Department's response to further information requested by the IPC

Figure 1 | Millennium Towers north-western view from lower tower location (RL 29.6) towards Darling Harbour and the site.

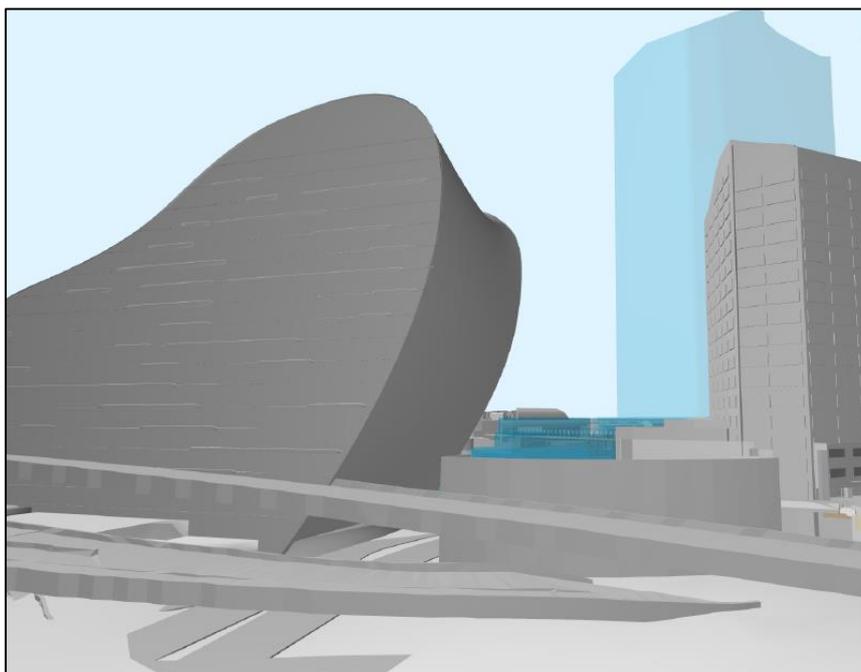
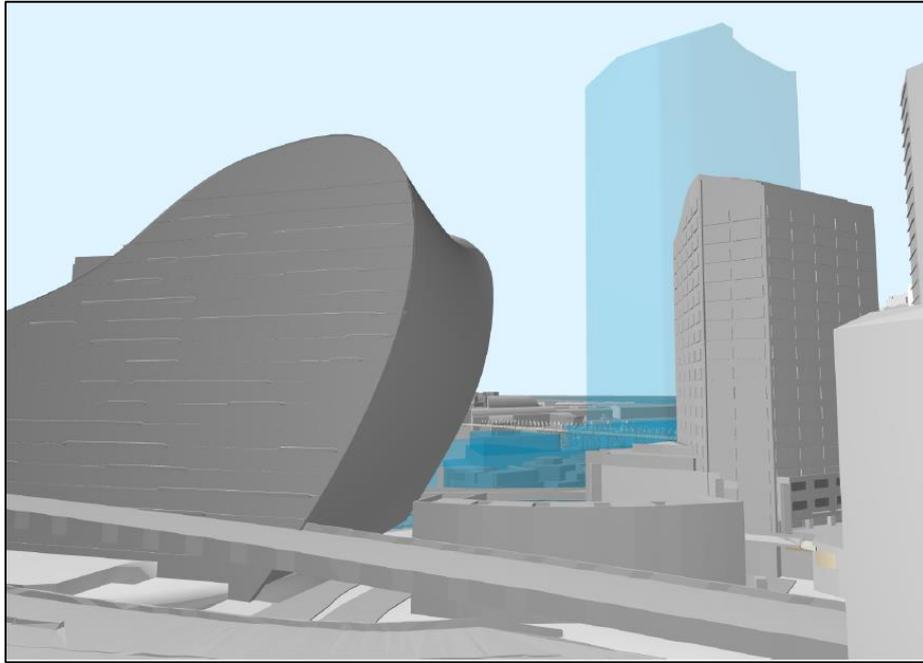
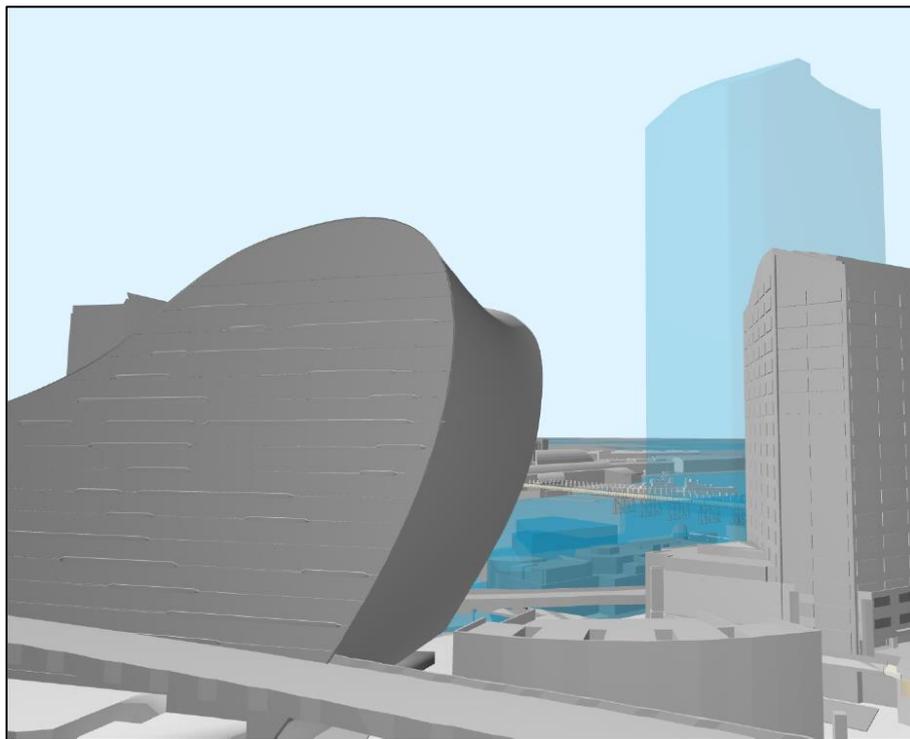
Ms D McAuliffe. Pg 11& 12 within the Public Meeting Transcript: The Commission would appreciate a response to the speaker's concerns regarding the Department's assessment of Millennium Towers.

With respect to the podium, the Applicant's VIA states that views of Cockle Bay water and Pyrmont Bridge are unlikely to be affected by the podium element of the concept envelope. Noting that the VIA does not include comparative views analysis of the existing and proposed podium, the Department requested additional images from the Applicant to ascertain the view impacts of the proposed podium (**Figures 1-3**). The comparative images demonstrate that the increased height of the podium at its southern end will result in additional view impacts compared to existing and in the case of the lower floor apartments of Millennium Towers, would obscure existing views of the water and Pyrmont Bridge.

Following assessment of the comparative images, the Department considers the view impacts to Millennium Towers to range from minor at upper levels to moderate at middle and lower floor levels.

The view impacts identified at Millennium Towers do not alter the Department's conclusions with respect to the reasonableness of the proposal (Tenacity Step 4 at p69 and 70 of the report). The Department notes the while the proposal would change the view from these apartments, Millennium Towers is located a significant distance from the site where there is a lower expectation of view
